Meeting Date:
May 16, 2024

Location:
56 Lake Forest Drive

Request
A variance request for a side yard setback

Case Manager:
Lauren Coffman,
Associate Planner

Site Plan
Scale: 1" = 20'-0"

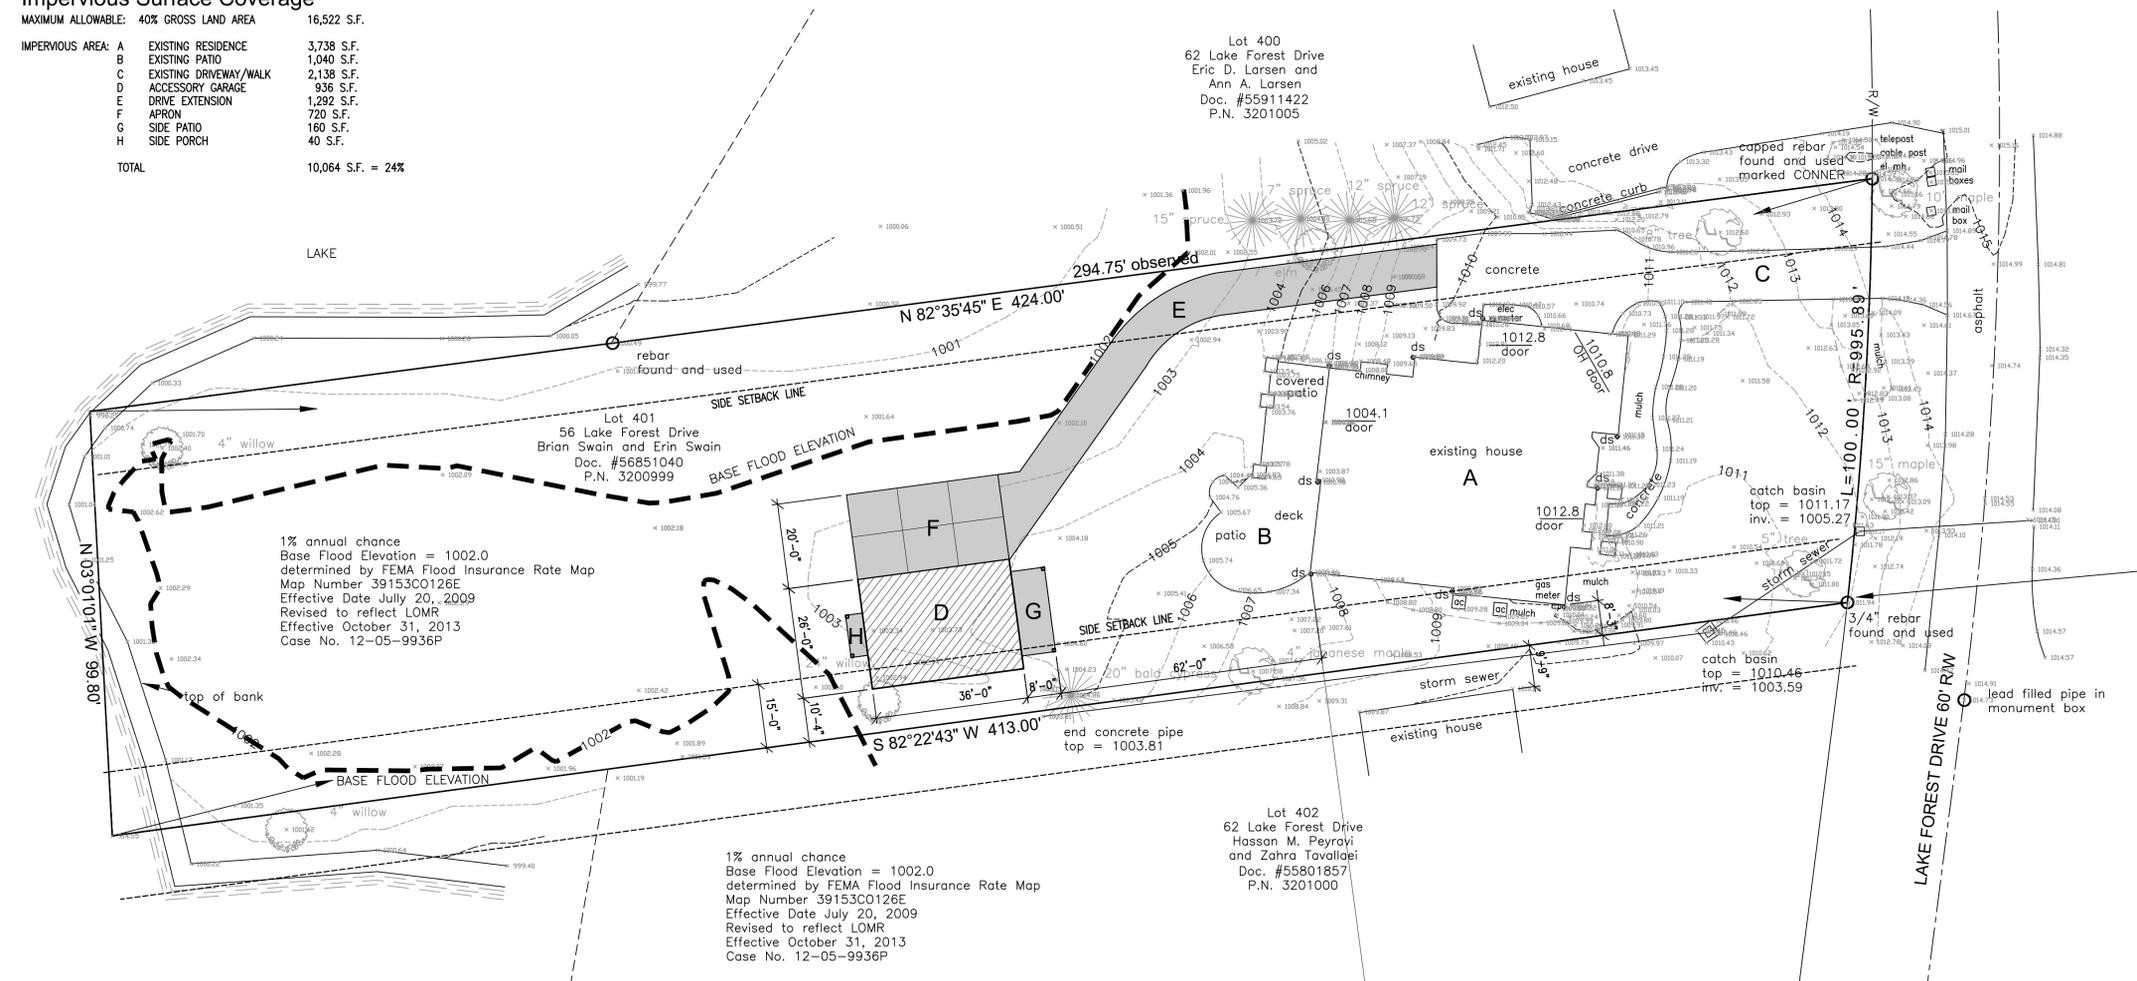
The property in question will yield a reasonable return and there can be beneficial use of the property without the variance as the property in question already has an existing 2 car attached garage and sufficient area existing in the rear yard to comply with the required setback. The proposed 10 ft setback would also impact existing trees along the shared property line

Staff questions if the garage could be sited further to the north to allow for additional room and increase the side yard setback in order to meet all Land Development Code requirements.
